**Subject:** Response to U.S. EPR Design Certification Application RAI No. 442, FSAR Ch. 7, Supplement 13

**Question 07.03-32:**

After reviewing the applicant's response to RAI 285, Question 07.03-27, the staff requests the applicant to explicitly identify in Chapter 7 which Protection System (PS) manual functions are credited in the safety analysis.

Figure 7.3-1—~~Typical~~ ESF Actuation  
(Sheet 1 of 5)

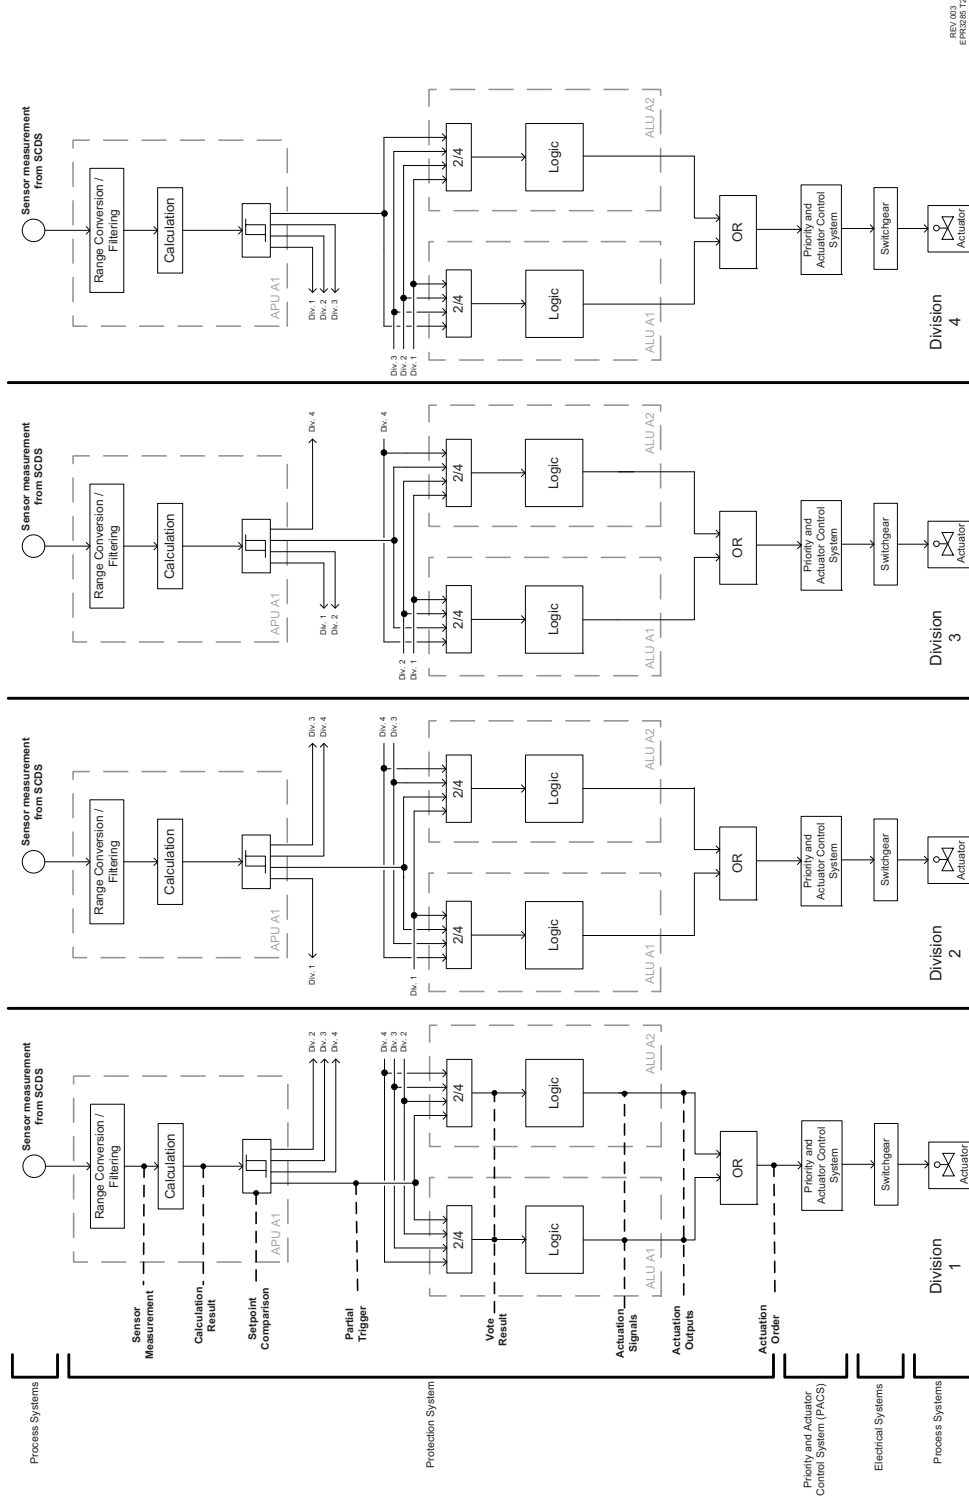
control system (PACS) for prioritization and interface to the actuators. ~~The typical~~ An example of an ESF actuation sequence ~~performed~~ actuated by four divisions of the ~~protection system~~ PS is illustrated in Figure 7.3-1 (Sheet 1), and is described as follows:

**Figure 7.3-1—ESF Actuation  
(Sheet 2 of 5)**

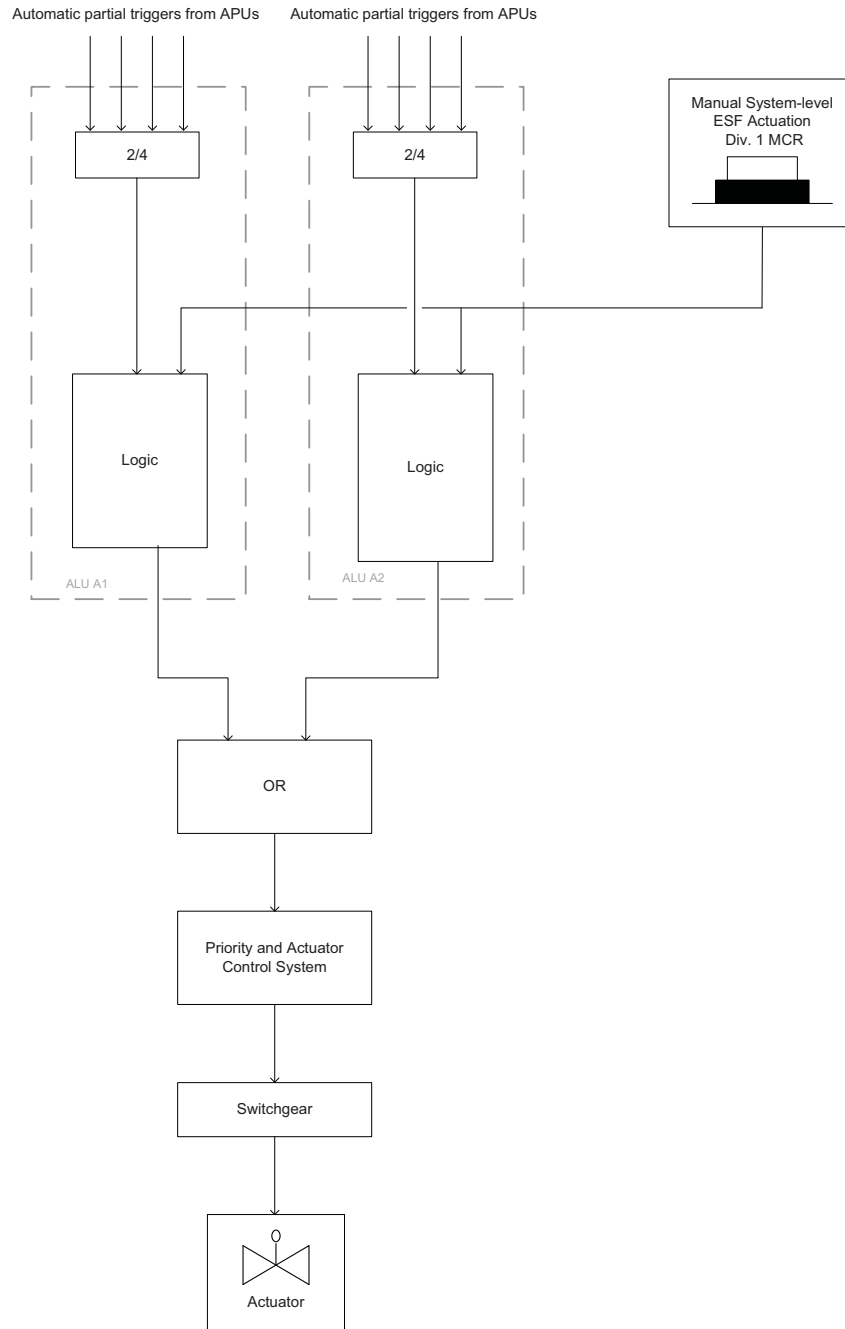
the safety-related actuation path and PICS is the non-safety-related actuation path. For any ESF actuator commands from the SICS have priority over those from the PICS. The manual system-level ESF actuation sequence is shown in Figure 7.3-1 (Sheet 2). The manual actuations are described with the corresponding automatic function in Sections 7.3.1.2.

07.03-32

Figure 7.3-3—EFWS Actuation

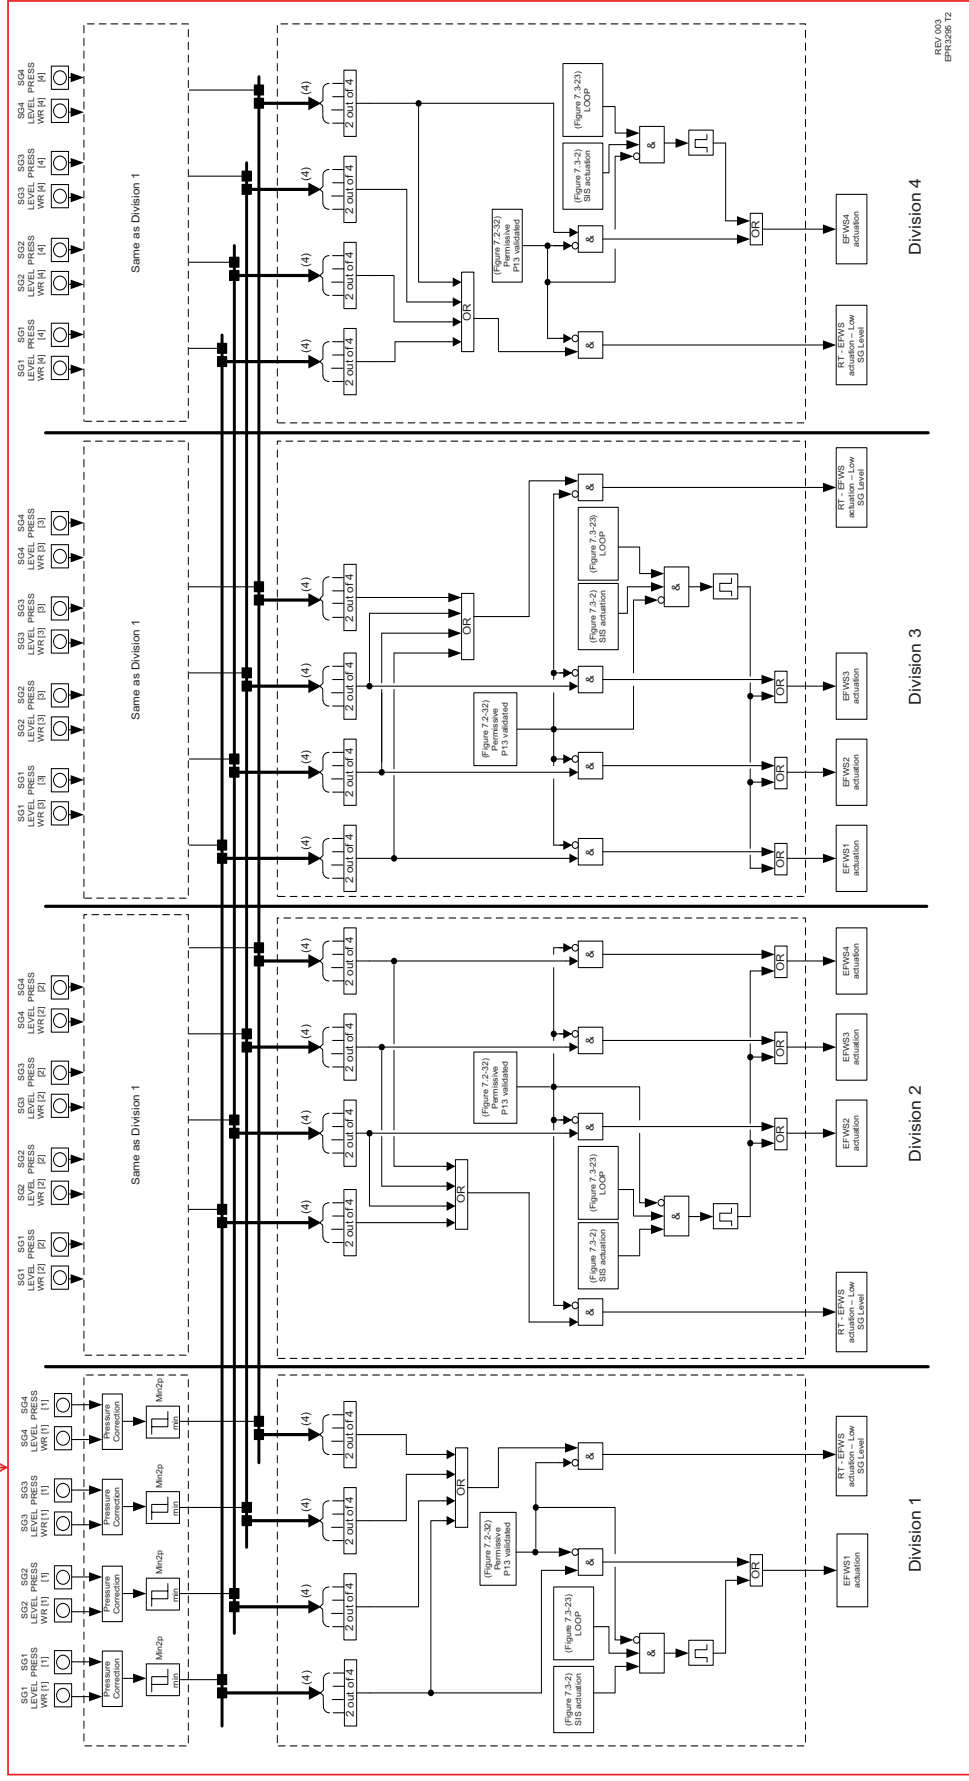
07.03-32

07.03-32

Figure 7.3-4—EFWS SG Level Control and Pump Flow Protection

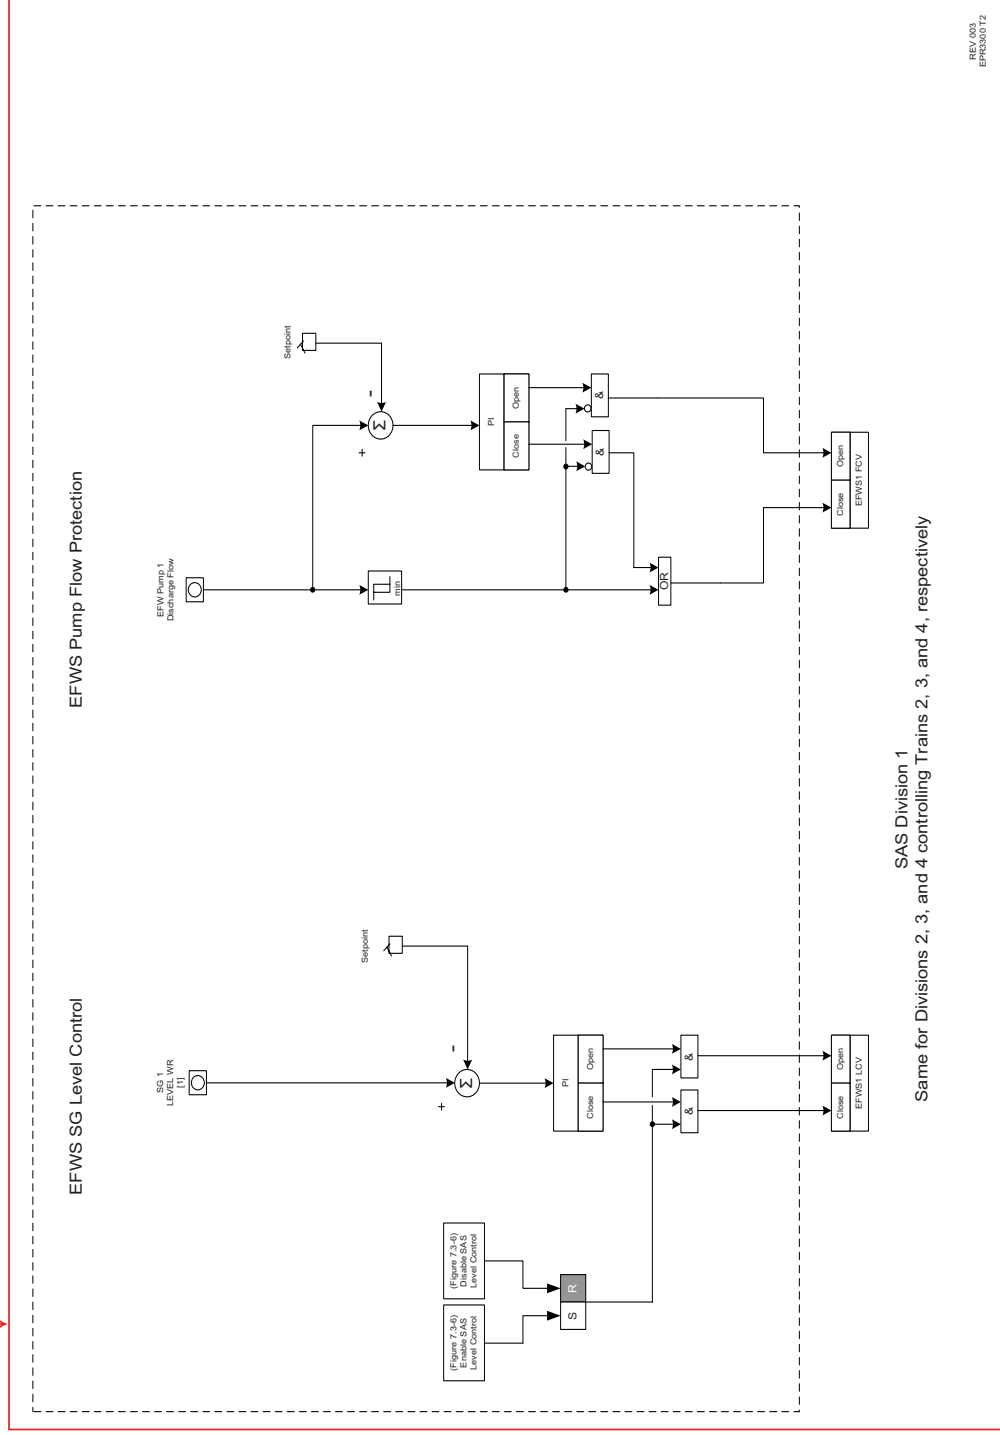
07.03-32

Figure 7.3-8—Partial Cooldown Actuation

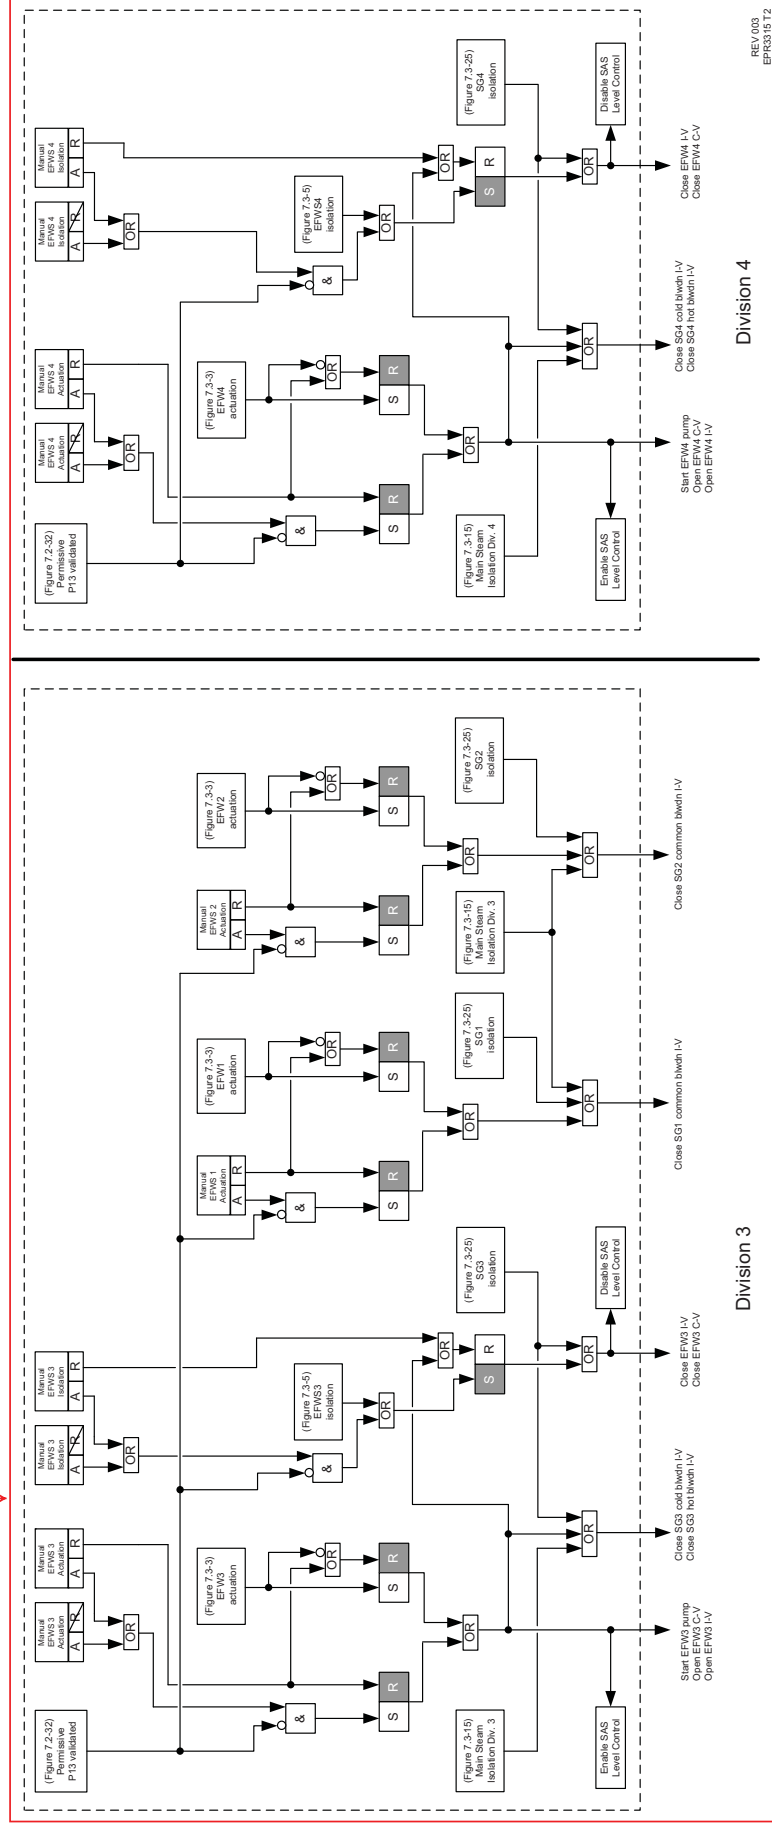
07.03-32

Figure 7.3-11—MSR/V Opening (Div. 3&4)

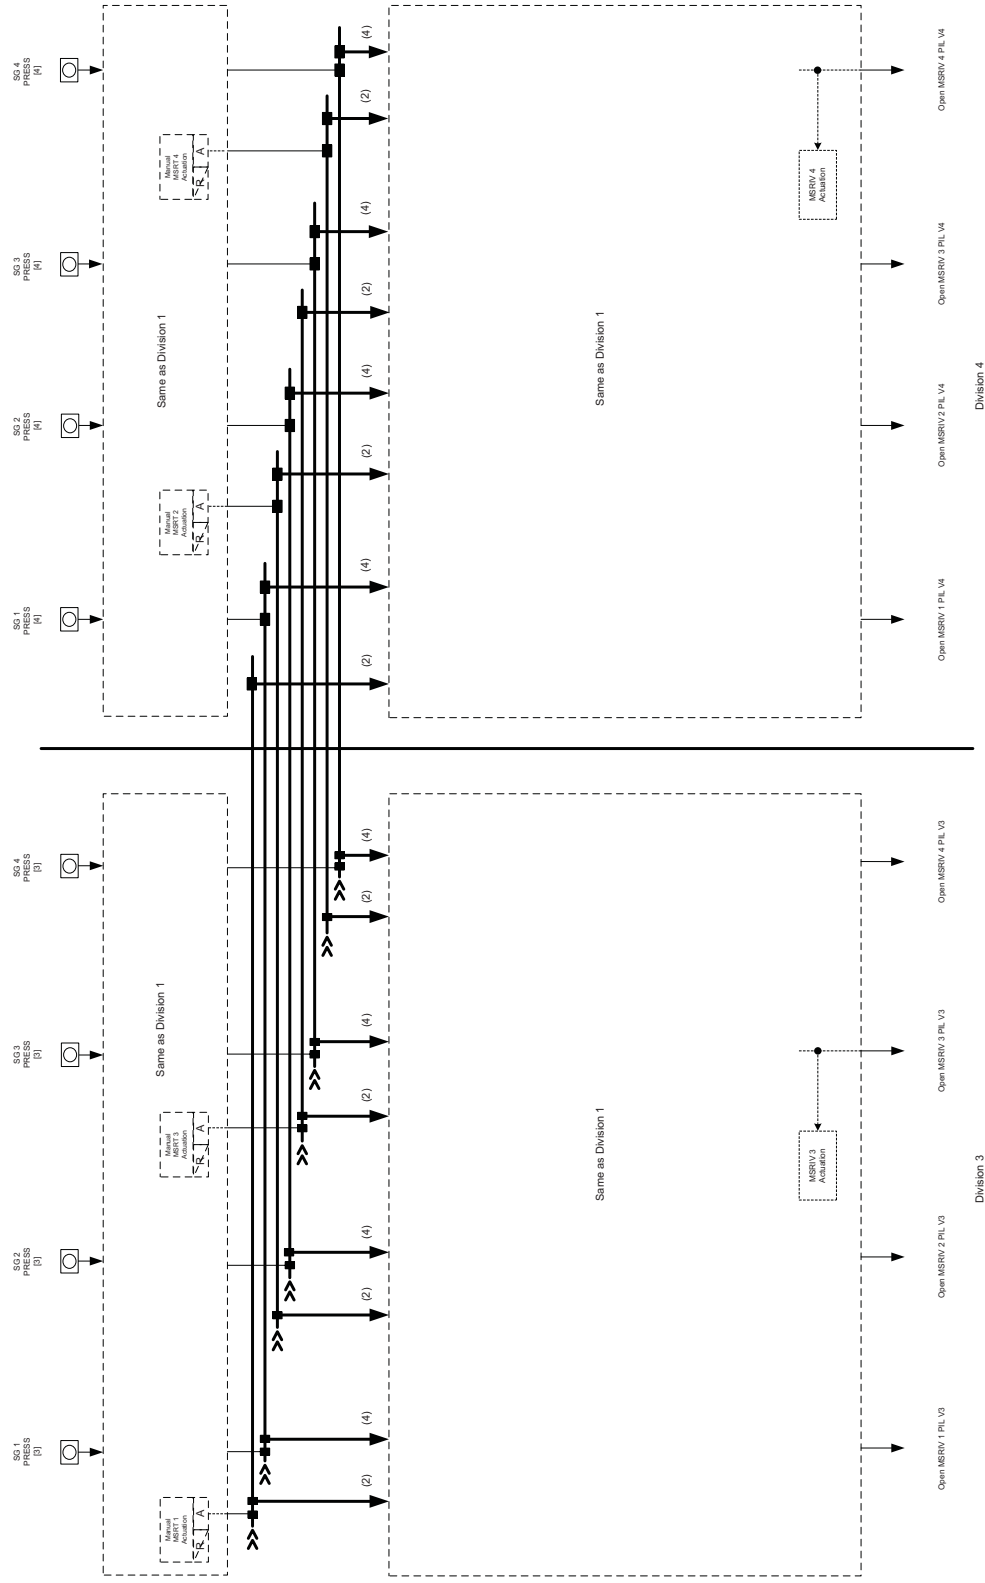
07.03-32

Figure 7.3-14—MSIV Main Steam Isolation (Div. 1 & 2)

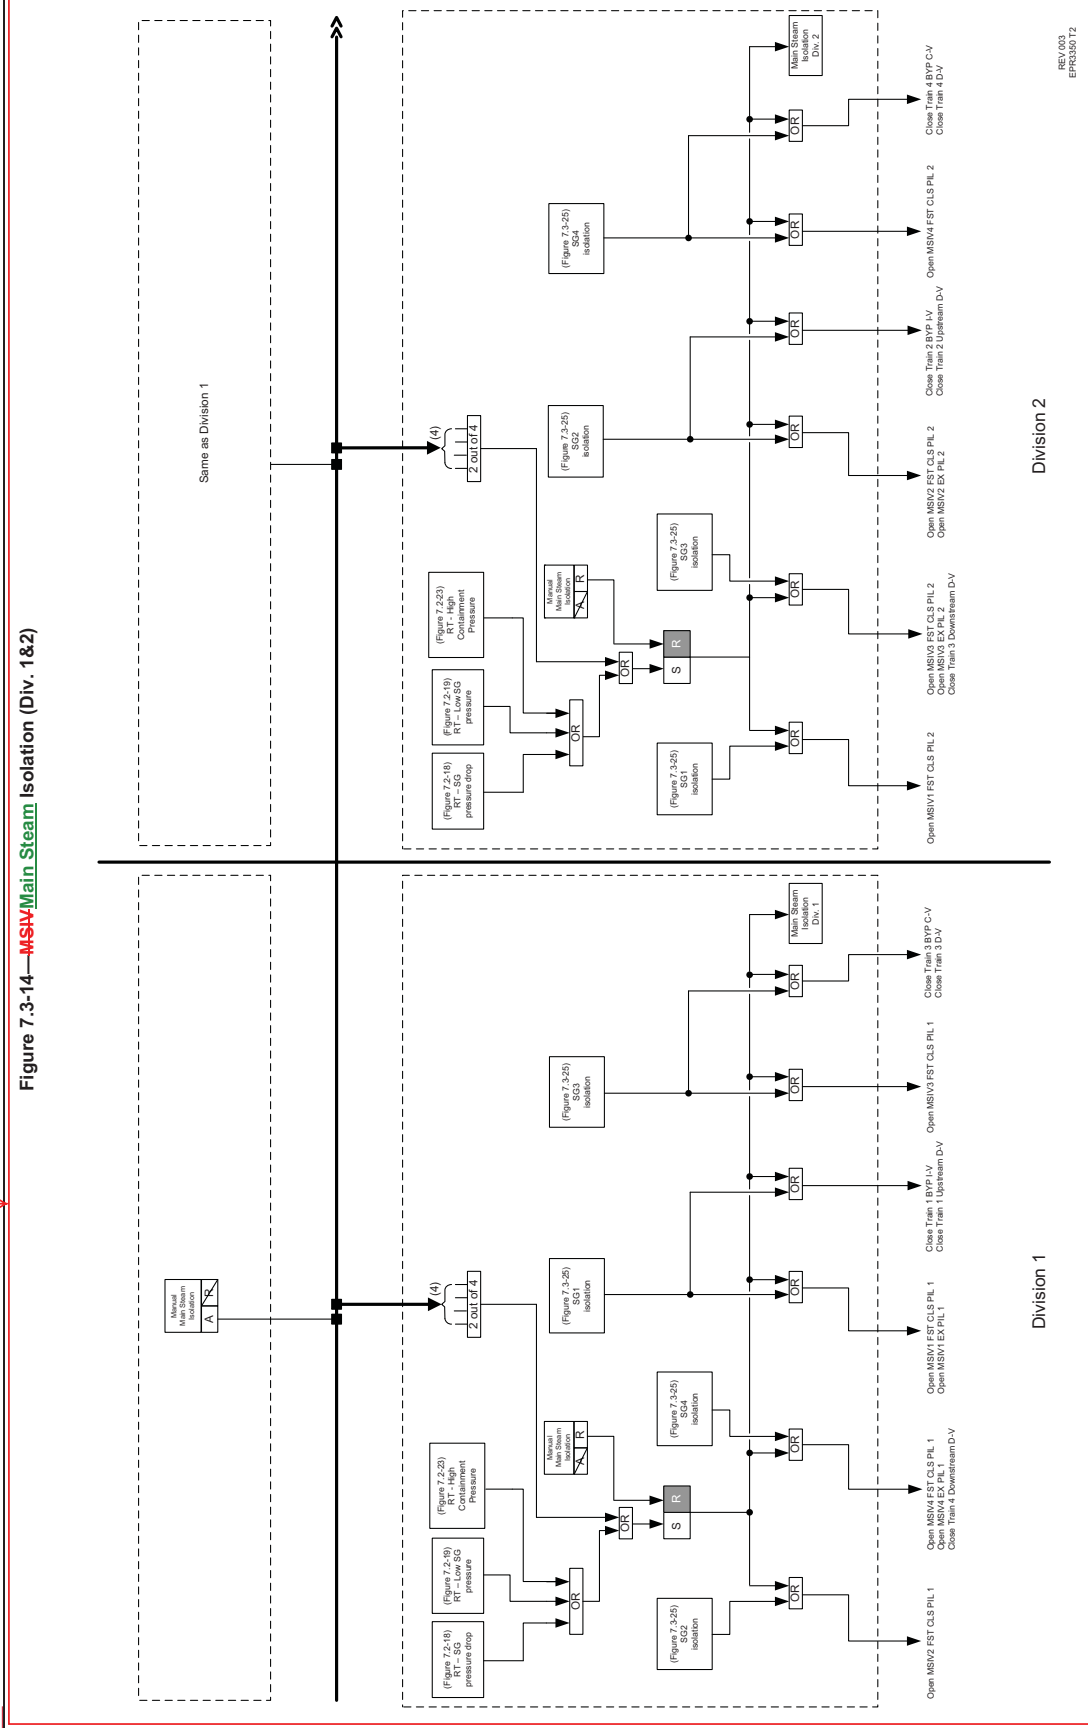
07.03-32
